Report Type: DA Access Report
Reference Number: 19293
Client: Designcorp
Site Address: 6 Edna Street, Kingswood, NSW

ACCESS REPORT

This Access Compliance Report is to accompany a Development Application for the development proposed at 6 Edna Street, Kingswood, NSW

Drawing no	Issue	Date	Details
E2	E	16-09-2020	Basement/ Ground floor plan
E3	E	16-09-2020	First floor plan
E7	E	16-09-2020	Details

[Image description: Plan above shows the provision of Accessible parking spaces]

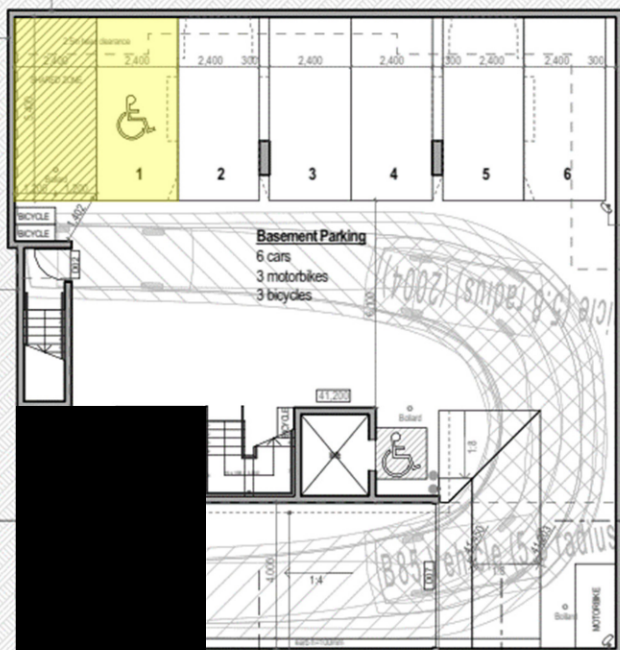
Requirement	Class 1b and 3 For Accessible parking requirements for boarding house, guest house, hostel etc. Multiply total number of carparking spaces provided by the % of <ul style="list-style-type: none"> - Accessible SOUs to the total number of SOUs or - Accessible bedrooms to the total number of bedrooms Calculated to the next whole number For Accessible parking requirements for residential part of school, accommodation for the aged, the disabled or children, residential part of health care building etc. <ul style="list-style-type: none"> - 1 space per 100 carparking spaces
Compliance Comments	Complies. Total number of carparking spaces provided = 6. Total number of accessible parking spaces required / provided as per the formula listed above in the requirements = 1. Detailed features of the accessible parking space to be verified at CC stage of works.
